DEVIATION REQUEST AND DECISION FORM

Project Name :	Crossroads North
Schedule No.(s) :	5408001008, 5408001029, 5408001032, 5408001033, 5408001034, 5408001041, 5408001042, 5408001050, 5408001051, 5408001052
Legal Description :	LOTS 12, 13, 14, 15, 16 AND 18, HILLCREST ACRES, ACCORDING TO THE PLAT THEREOF RECORDED MAY 12, 1960 AT RECEPTION NO. 153860, EXCEPT THAT PORTION ACQUIRED BY THE DEPARTMENT OF TRANSPORTATION, STATE OF COLORADO AS DESCRIBED IN RULE AND ORDER RECORDED APRIL 28, 2004 UNDER RECEPTION NO. 204068322, AND EXCEPT THOSE PORTIONS CONVEYED TO EL PASO COUNTY BY AND THROUGH THE BOARD OF COUNTY COMMISSIONERS OF EL PASO COUNTY, COLORADO BY SPECIAL WARRANTY DEED RECORDED DECEMBER 17, 2014 AT RECEPTION NO. 214116021 AND RECORDED DECEMBER 17, 2014 AT RECEPTION NO. 214116022, COUNTY OF EL PASO, STATE OF COLORADO. LOT 17, HILLCREST ACRES, COUNTY OF EL PASO, STATE OF COLORADO, EXCEPT THAT PORTION CONVEYED TO EL PASO COUNTY BY AND THROUGH THE BOARD OF COUNTY COMMISSIONERS OF EL PASO COUNTY, COLORADO BY SPECIAL WARRANTY DEED RECORDED DECEMBER 30, 2014 AT RECEPTION NO. 214119767. LOT 19, HILLCREST ACRES, COUNTY OF EL PASO, STATE OF COLORADO, AS AMENDED BY SURVEYOR'S STATEMENT RECORDE

SCALE: NOT TO SCALE

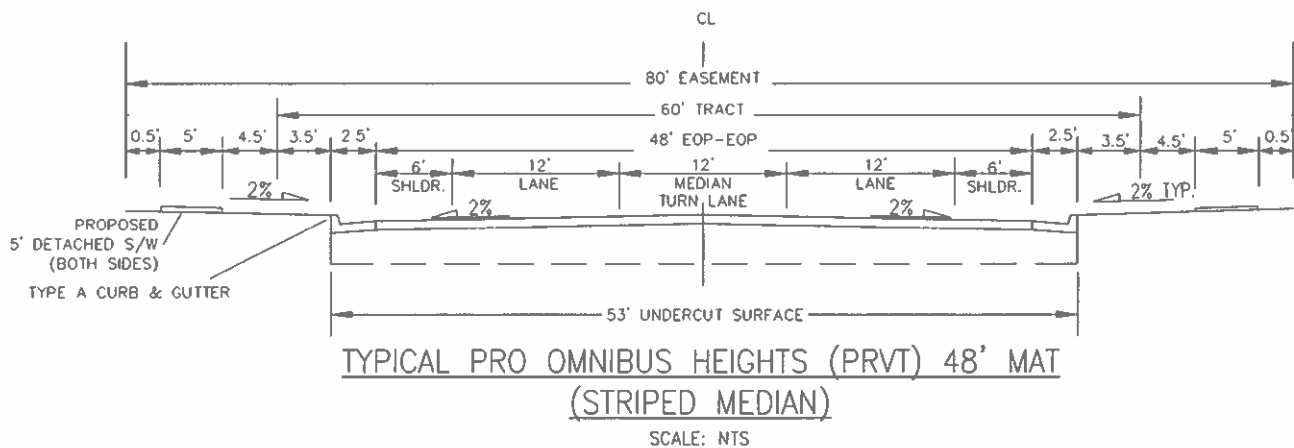
A deviation from the standard Urban Non-Residential Collector Roadway Cross Section for Pro Omnibus Heights and Nox Album Point is requested. The standard cross section includes two travel lanes (12'), a striped median (12'), and two shoulders (6') within a 48-foot wide pavement mat; two 2.5-foot curb and gutter at the end of the pavement mat, two eight (8) foot (typical) landscape/tree lawns, two five (5) foot detached sidewalks all within an 80-foot ROW. A deviation from the minimum centerline radius for Urban Non-Residential Collector Roadways is also requested. The minimum radius is 565 feet.

Roadway Design Parameters
 Design Speed: 40 mph
 Posted Speed: 35 mph
 Maximum ADT: 20,000
 Design Vehicle: WB-50

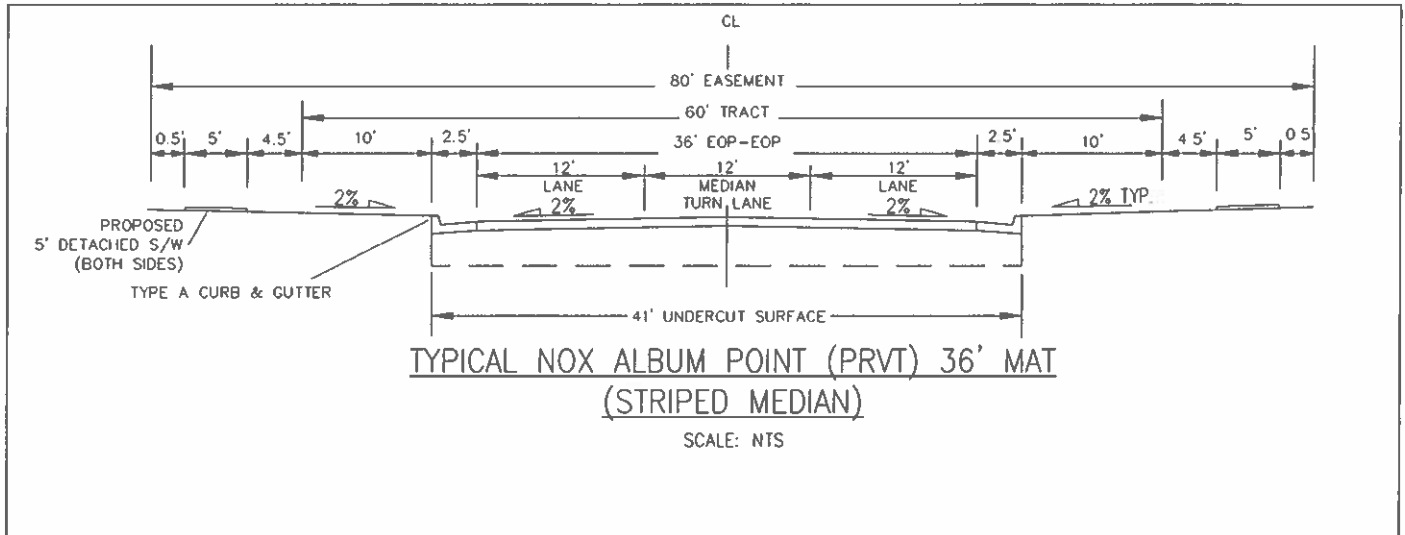
The proposed private road cross section includes the following deviation(s) from standard ECM Standards for an Urban Non Residential collector section. Requesting for Pro Omnibus Heights and Nox Album Point;

- 60-foot Tract. Typical cross section is within an 80-foot easement.
- 48 foot pavement width, where typical cross section has a 48' pavement width. No Change Pro Omnibus Heights.

- 36 foot pavement width, where typical cross section has a 48' pavement width. Nox Album Point.
- Two 12-foot travel lanes, where typical cross section has two 12-foot travel lanes with two 6' shoulders. No Change

- Nox Album Point does not have 6' shoulders.
- Striped 12' median, whereas typical cross section has 12' striped median. No Change.
- 5-foot detached sidewalk, where typical cross section has 5' detached sidewalks, No Change.

- 200' minimum centerline radius (standard for urban local roadways) whereas typical cross section is 565' minimum centerline radius.
- Two 8' landscape/tree lawns. Typical cross section has two 8' landscape/tree lawns. No. change.

- Nox Album Point will have two 14.5' landscape/tree lawns.
- 25 MPH design speed / 25 MPH posted speed (urban local), whereas typical cross section is 40/35 MPH.

- Typical cross section intersection spacing is 660' or 330' when intersecting local roadways. The layout of all of the commercial lots is not known at this time. Therefore, a deviation for the future applications will be necessary. Direct lot access allowance in conformance with ECM Section 2.4 is implied with this deviation for Lots 1-15. Each lot access will be reviewed with each application submitted.

- Parking will not be permitted. No Change.
